TO: Gulf of Mexico Fishery Management Council

FROM: Steve Cadrin, Independent Reviewer

RE: Peer Review of “The Great Red Snapper Count: Estimating the Absolute Abundance of Red Snapper in the U.S Gulf of Mexico”

Figure 1. Red snapper abundance in the eastern and western areas of the northern Gulf of Mexico estimated from the Great Red Snapper Count (GRSC) and the SEDAR52 stock assessment (SEDAR 2018; unfished, 1870-2016 estimates, 2017-2020 projections at the overfishing limit).

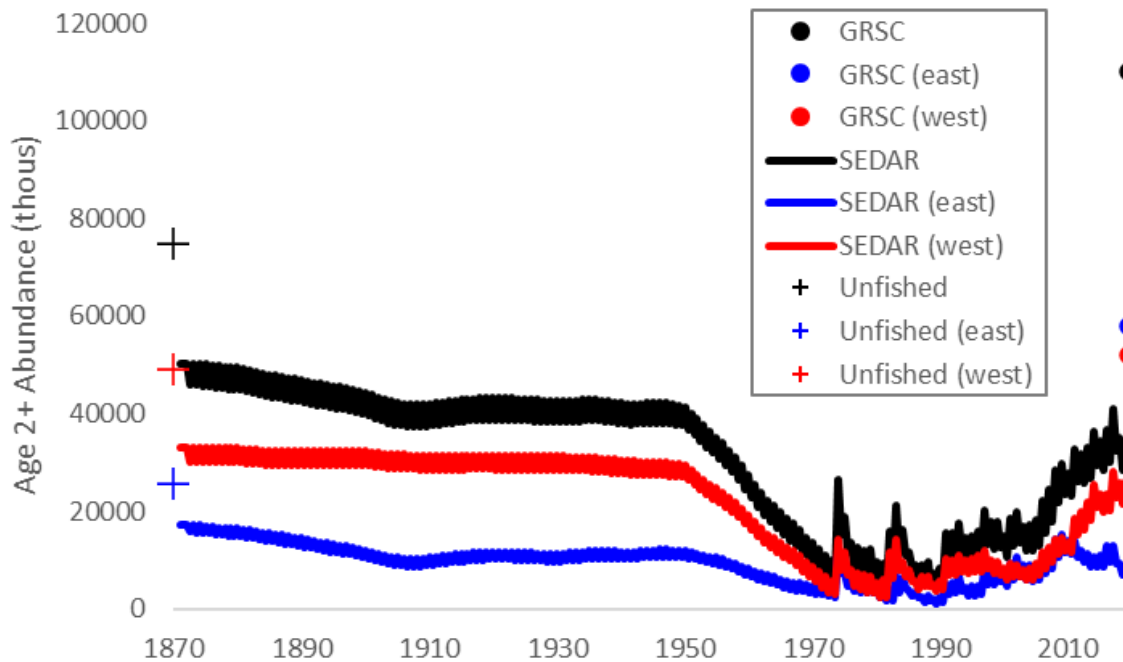
The estimate of age-2 red snapper abundance in late 2019 was 110 million with a CV of 11%. If the CV is correct, abundance estimates are appropriately reported in significant digits of 10-million. Because of the large area of uncharacterized habitat, those strata contributed the most to the stock-wide abundance estimate. As reported in section II.F.2.c (estimate reconciliation) the estimate of abundance is substantially greater than contemporary estimates from the SEDAR52 stock assessment. The stock-wide estimate of age-2+ abundance is about four times greater than the projected 2019 abundance and greater than estimates of unfished stock abundance from the SEDAR52 stock assessment (Figure 1. below; SEDAR 2018; age-2+ estimates and projections from M. Smith).

The estimated spatial distribution of the resource is relatively even (53% eastern regions, 47% western regions), which is substantially different than the spatial distribution estimated by the SEDAR52 assessment (21% eastern area, 79% western area; Figure 1). Stock assessments are typically better at assimilating data and estimating relative stock status than they are at estimating absolute stock size, but the different perspectives of spatial distribution raises concerns that the apparently even spatial distribution may result from unequal sampling efficiencies of the different sampling methods used in each region. Most hard bottom was in the Florida strata, sampled with optic methods, but most oil and gas platforms were in western region, sampled with acoustic methods. Estimates of abundance assumed 100% detection, but paired comparisons show that acoustic sampling has much lower detection. Therefore, abundance in western regions may be substantially underestimated, and including them in an integrated stock assessment may impose conflicting information on scale.
